Corrections Needed in Clause 180.9.6

Norman Swenson
Affiliated with Nokia, Point2
Aug 24, 2026

Addresses Comments: R2-188, R2-189, R2-16, R2-17, R2-18

Figure 180–10—TDECQ reference equalizer functional model

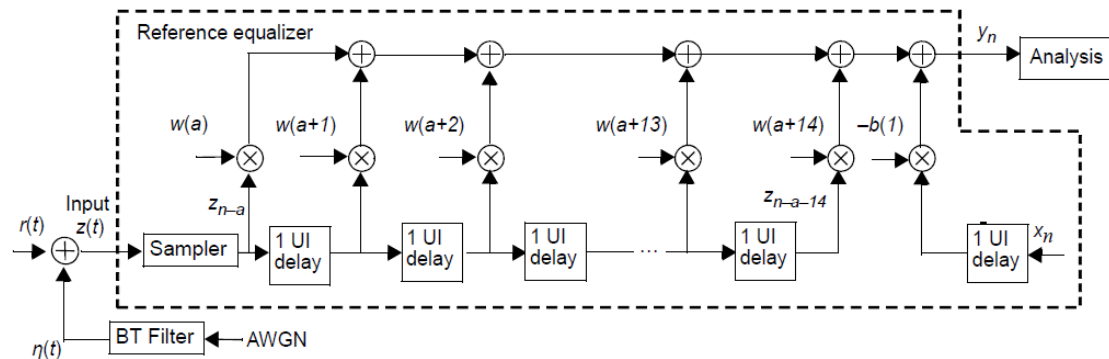
The equalizer is modeled as shown in Figure 180–10, where

- $r(t)$ is the output of the reference receiver defined in 180.9.2, with the mean value subtracted from the signal
- $\eta(t)$ is colored Gaussian noise, generated from additive white Gaussian noise (AWGN) filtered by a Bessel-Thomson (BT) filter as defined in 180.9.2
- $z(t)$ is the input signal given by Equation (180–1)
- z_n is the sampled response of input signal $z(t)$, given by Equation (180–2)
- v_n is the equalizer output corresponding to x_n
- X_n is the n th symbol in the test pattern sequence, $X_n \in \{0, 1, 2, 3\}$, and x_n is given by Equation (180-3)
- w is the set of feed-forward tap coefficients, given by Equation (180- 4)
- $b(1)$ is the feedback tap coefficient
- the feedback is modeled as correct, i.e., x_n is the pattern used to generate the input $r(t)$
- the received signal $r(t)$ is aligned with the test pattern such that $r(nT)$ corresponds to x_n

$r(t)$ is no longer a power, as the mean has been subtracted off, and y_n is a discrete-time signal, not a continuous-time signal. The method defined in 180.9.5 is for a continuous-time signal with runs of threes and runs of zeros. I suggest introducing a continuous-time signal when we introduce the eye diagram, then use that to define OMA_{TDECQ} .

The eye diagram reflects a continuous-time waveform $y(t)$ corresponding to y_n , where $y(t)$ would be the output of a continuous-time equalizer obtained by removing the sampler in Figure 180-10.

Figure 180–11—Illustration of the TDECQ measurement

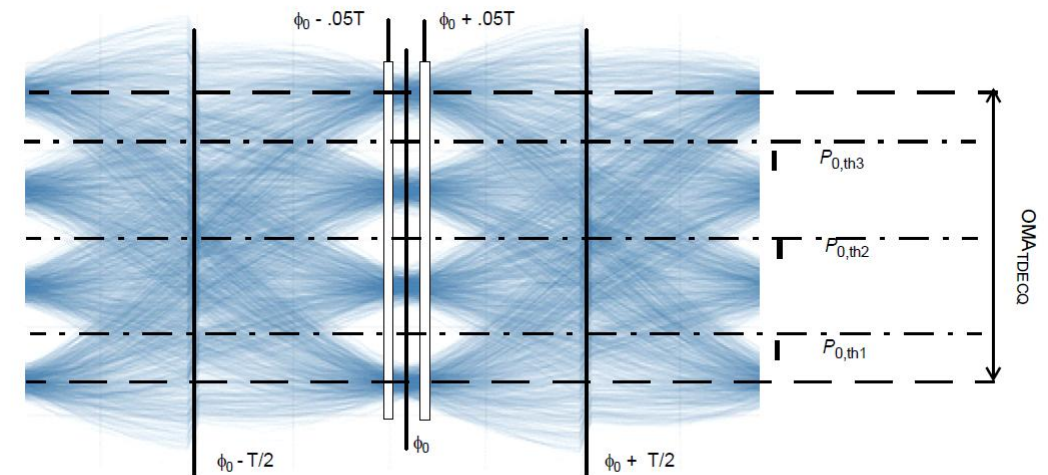
An eye diagram to help illustrate TDECQ is shown in Figure 180–11. The eye diagram corresponds to the optimized equalizer setting at sampling phase ϕ_0 . The feedback symbol x_n changes at phase $\phi = \phi_0 - T/2$.

An eye diagram to help illustrate TDECQ is shown in Figure 180–11. The eye diagram corresponds to the optimized equalizer setting at sampling phase ϕ_0 . The feedback symbol x_n changes at phase $\phi = \phi_0 - T/2$.

value to x_{n+1} at time $t = nT + \phi_0 + T/2$.

The nominal threshold levels $P_{0,th1}$, $P_{0,th2}$, and $P_{0,th3}$, are ~~determined from the OMA_{TDECO} and the average optical power P_{ave}~~ defined in Equation (180-4), Equation (180-5), and Equation (180-6), and illustrated in Figure 180-11.

$$P_{0,th1} = \cancel{P_{ave}} - \frac{OMA_{TDECO}}{3} \quad (180-4)$$

$$P_{0,th2} = \cancel{P_{ave}} \quad 0 \quad (180-5)$$

$$P_{0,th3} = \cancel{P_{ave}} + \frac{OMA_{TDECO}}{3} \quad (180-6)$$

where OMA_{TDECO} is measured on the equalized captured waveform $y(t)$, using the method defined in 180.9.5, and where $y(t)$ is the continuous time waveform corresponding to the eye diagram shown in Figure 180-11.
